CITY OF LA VISTA
MAYOR AND CITY COUNCIL REPORT
JULY 19, 2016 AGENDA

Subject:	Type:	Submitted By:
APPLICATION FOR PRELIMINARY PLAT, LOTS 1-7, BRENTWOOD CROSSING, LOTS 8B & 8C, BRENTWOOD CROSSING REPLAT NO. 1, LOTS 8A1, 8A2, 8A3 & 8A4, BRENTWOOD CROSSING REPLAT NO. 2, AND PORTIONS OF TAX LOT 12, 14-14-12; AND WAIVER OF SECTION 4.24, SUBDIVISION REGULATIONS (SE OF 84 TH & SUMMER DR.)	◆ RESOLUTION ORDINANCE RECEIVE/FILE	ANN BIRCH COMMUNITY DEVELOPMENT DIRECTOR

RE: Preliminary Plat – Initial Review
La Vista City Centre

RE: Preliminary Plat – 2nd Review
La Vista City Centre

drawn by: CAS
checked by: ERG
approved by: ERG
QA/CC by: ERG
project no.: 016-0546
drawing no.: 04.04.2016
date: 04.04.2016

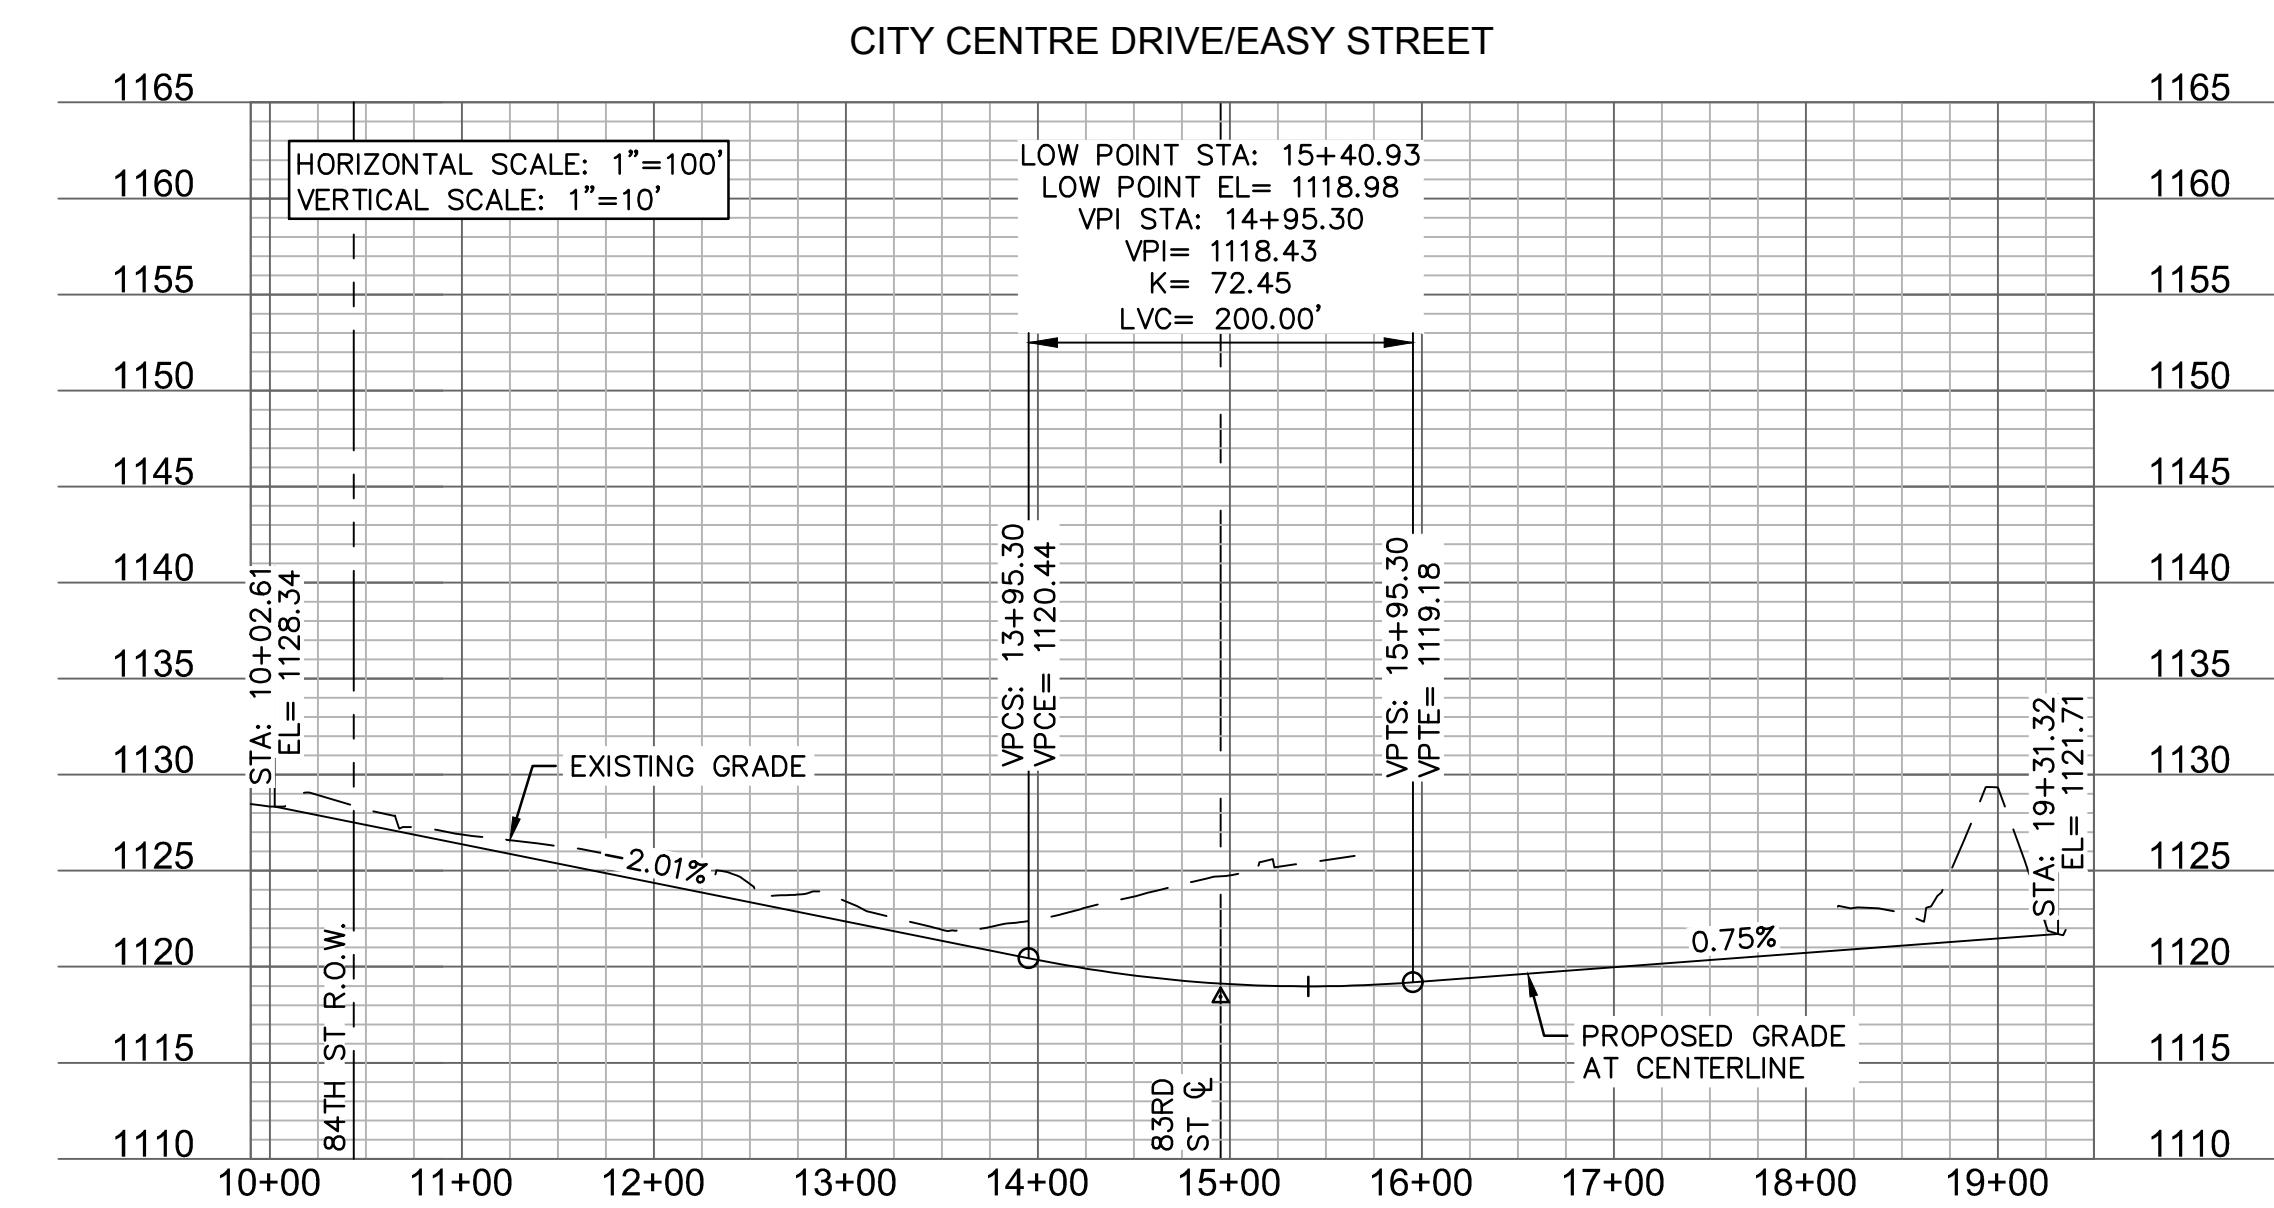
2. On Sheet C3.2 there needs to be a note added stating that a single grading and erosion control permit will be obtained for all lots in the preliminary plat. The fewest number of grading permits is preferred to allow for ease of administration and coordination of inspections as well as reducing permit costs for the applicant.

Response: Note has been added to the plan
